**PUD NO. 1 OF SKAGIT COUNTY
PIPELINE RELOCATION AT CEDARDALE ROAD PROJECT**

ADDENDUM NO. 1

Date of Issue: March 14, 2025

PIPELINE RELOCATION AT CEDARDALE
PLAN AND PROFILE
STA 6+50 TO STA 10+50
SCALE: 1"=20'
JOB ID: CP14019
SHEET: 4 OF 5

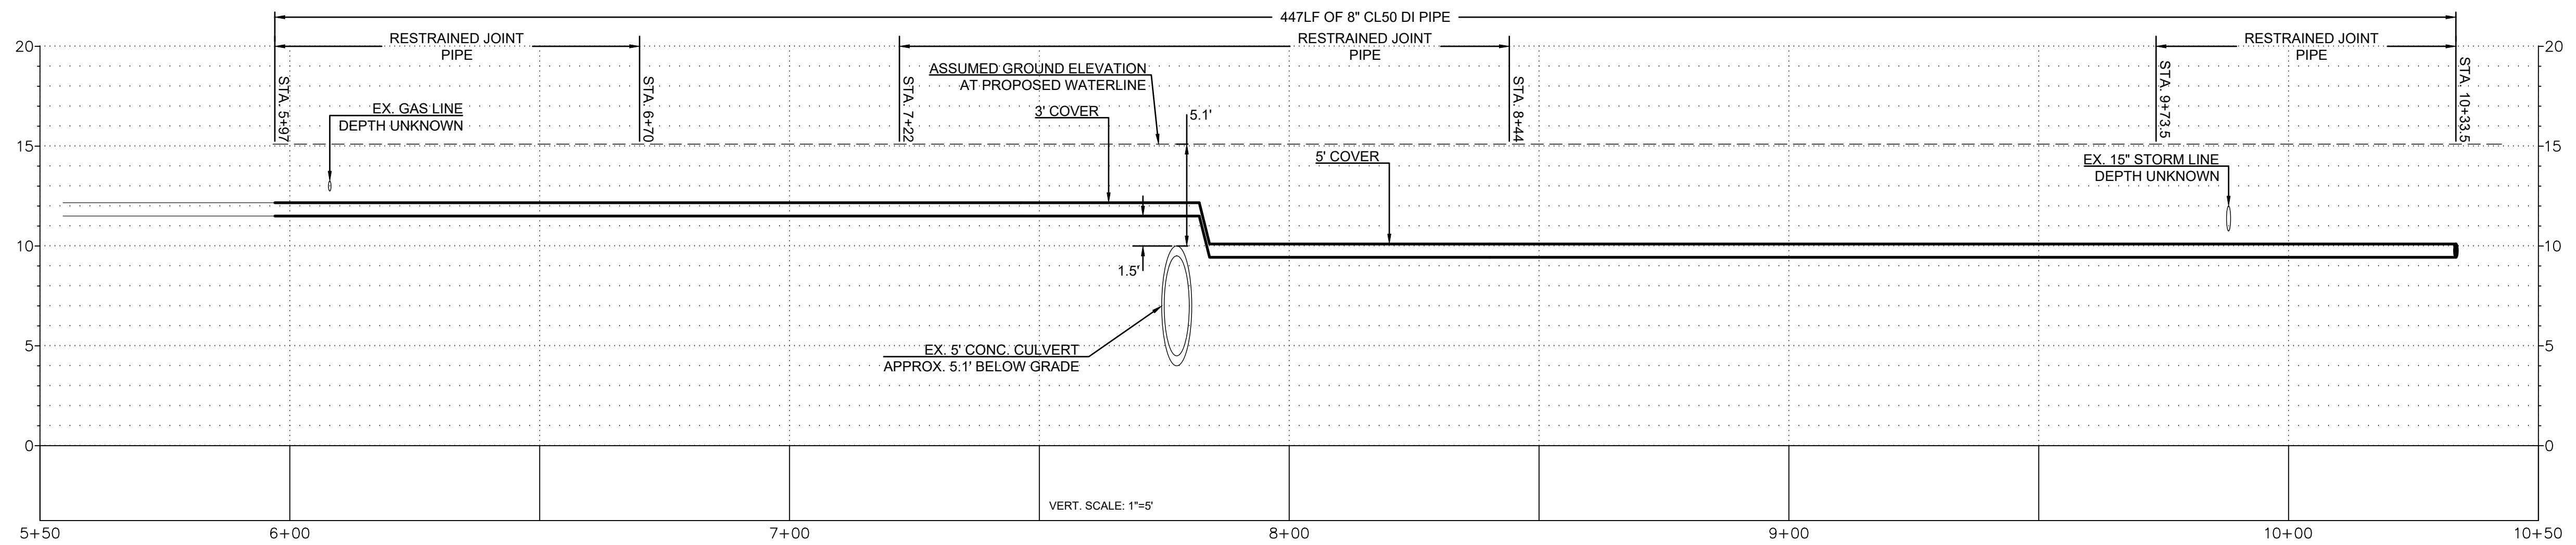
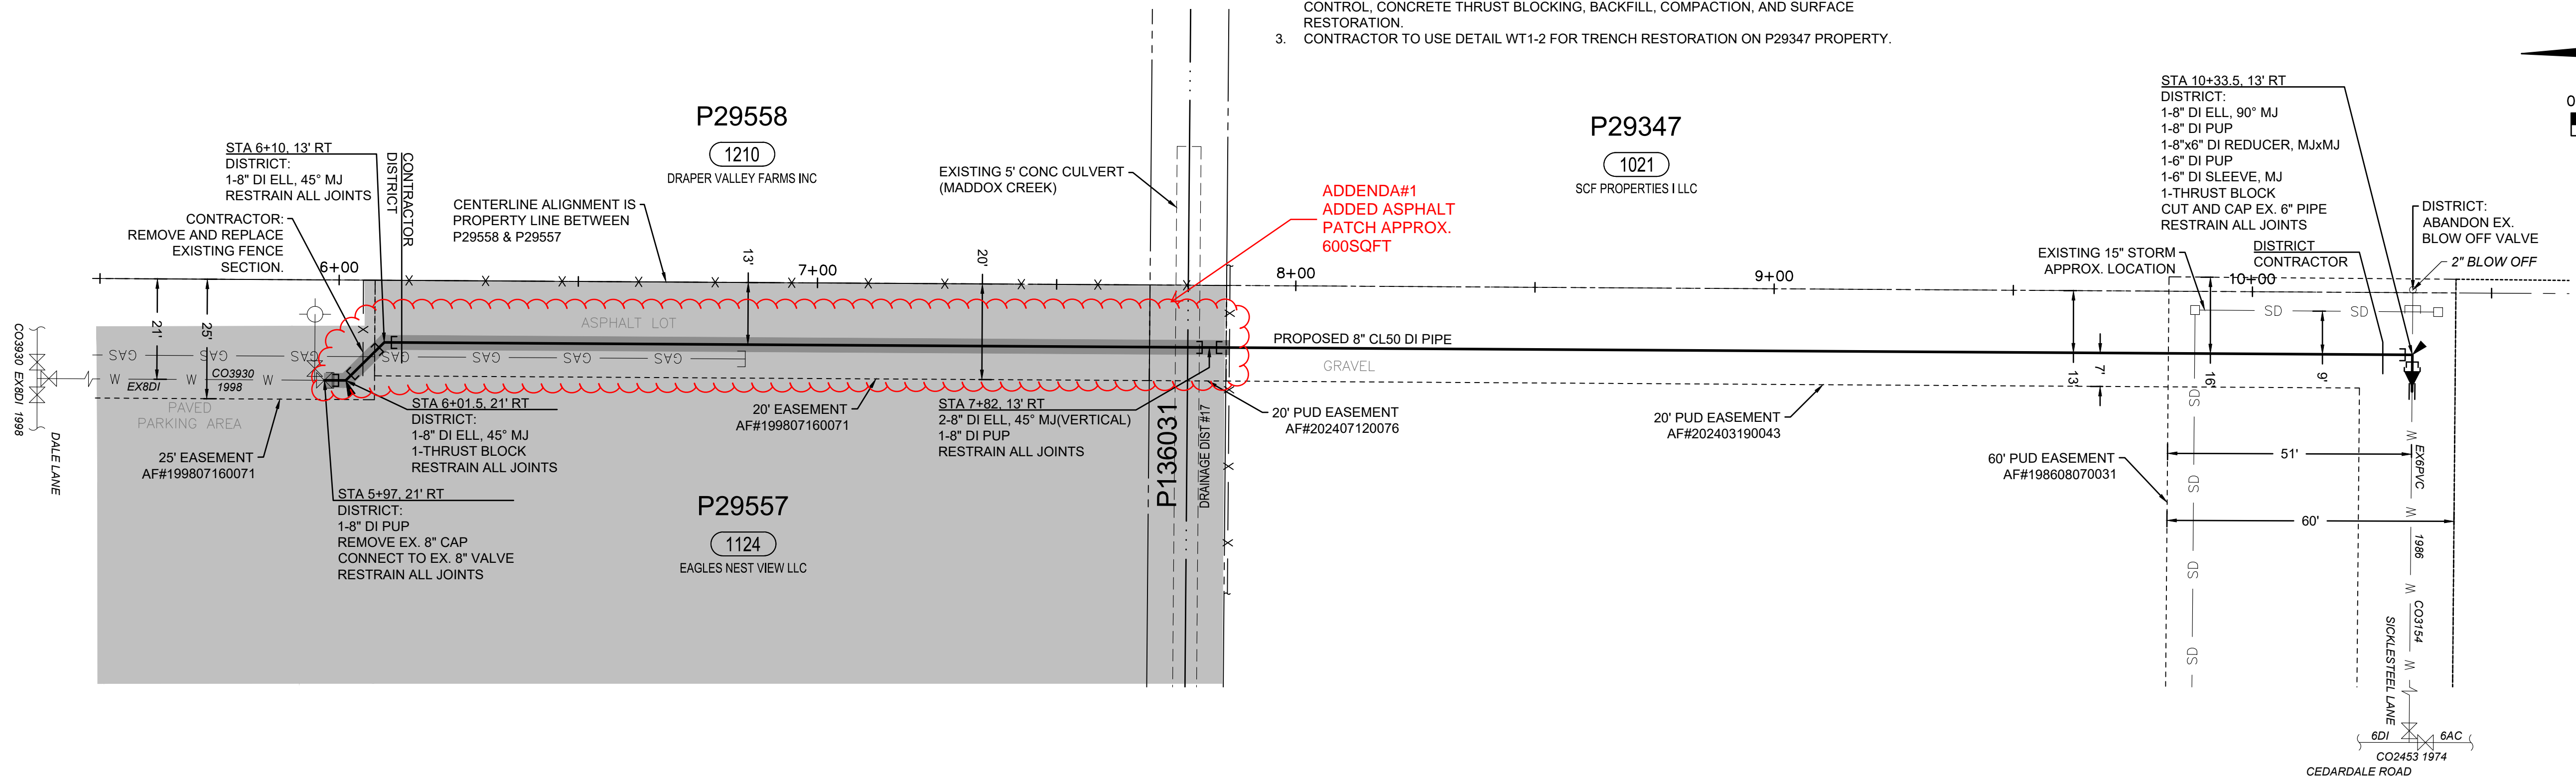
- a. Remove and replace Sheet 4 of 5 of the plans. Revisions to the plan include the addition of asphalt patching and the PUD providing tie-in materials in accordance with the pre-bid meeting Q&A.
